ORDINANCE NO. 120326

1
2
3 **An ordinance of the City of Gainesville, Florida, amending the Planned**
4 **Development commonly known as “One College Park” located in the vicinity**
5 **of the 1700 block between NW 1st Avenue and NW 2nd Avenue; by amending**
6 **City of Gainesville Ordinance No. 080753 that rezoned the property to**
7 **Planned Development and adopted the Development Plan; amending the**
8 **Planned Development to add “dormitory” as defined in this Ordinance to the**
9 **list of uses permitted by right under certain conditions; defining “dormitory”;**
10 **adopting a revised development plan report and revised development plan**
11 **maps; acknowledging extension granted pursuant to Ordinance No. 120129;**
12 **providing a severability clause; and providing an immediate effective date.**

PD ZONING SUBMITTAL PACKAGE FOR ONE COLLEGE PARK

SHEET
 PD-3

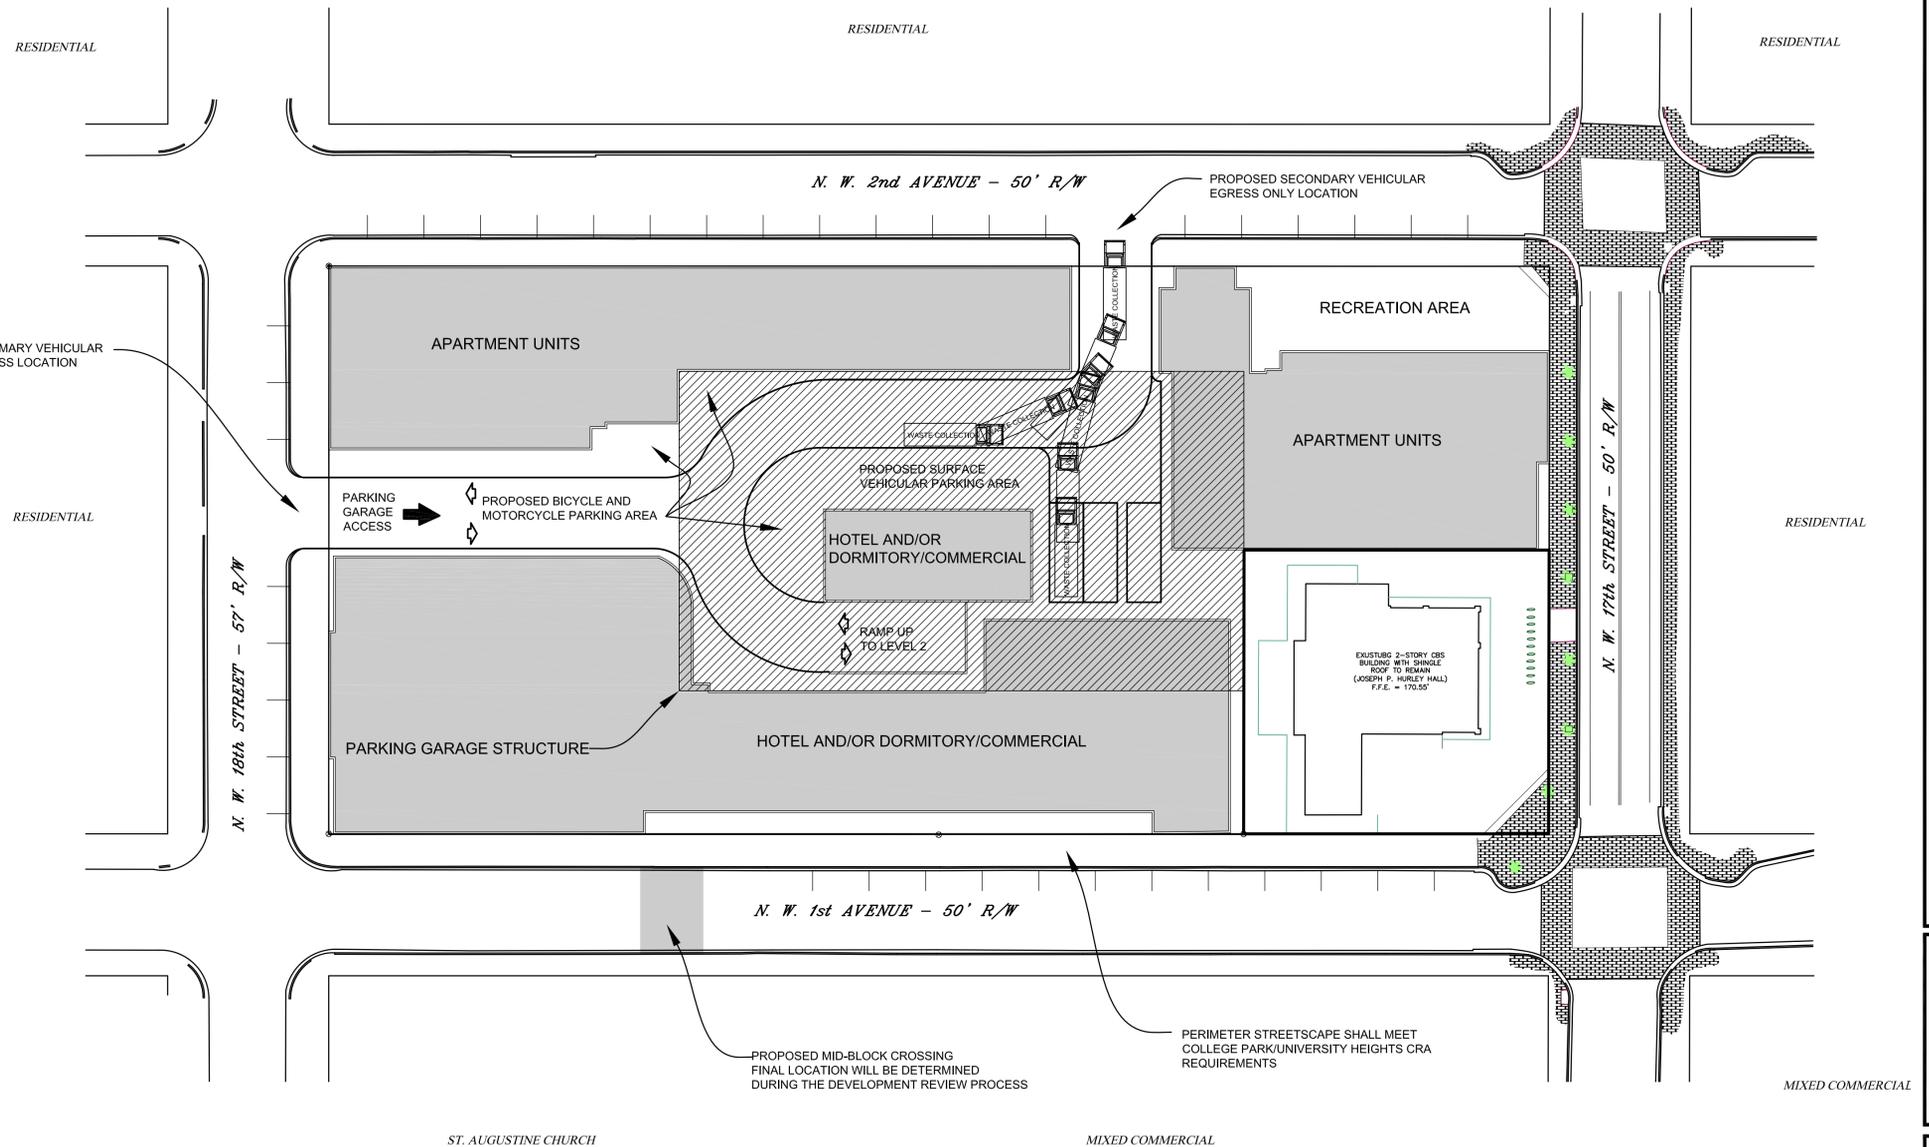
BUILDING DETAILS SHOWN ON THIS PD LAYOUT PLAN ARE FOR ILLUSTRATIVE PURPOSES ONLY. AREAS INDICATED FOR HOTEL AND/OR DORMITORY/COMMERCIAL, PARKING STRUCTURE AND PARKING ACCESS, APARTMENT UNITS AND RECREATION REFLECT THE USES AUTHORIZED AND THE AREAS FOR WHICH SUCH AUTHORIZATION IS GRANTED.

APARTMENT AREA = A MAXIMUM OF 22,000 SF
 HOTEL AND/OR DORMITORY/COMMERCIAL SPACE AREA (INCLUDES HOTEL OR DORMITORY AND RETAIL) = A MAXIMUM OF 26,000 SF
 STRUCTURED PARKING = A MAXIMUM OF 21,000 SF
 SHARED MECHANICAL AND OPERATIONAL SPACE = A MAXIMUM OF 1,558 SF
 OPEN SPACE = A MINIMUM OF 5,000 SF

TRIP GENERATION FOR DORMITORY LAND USE
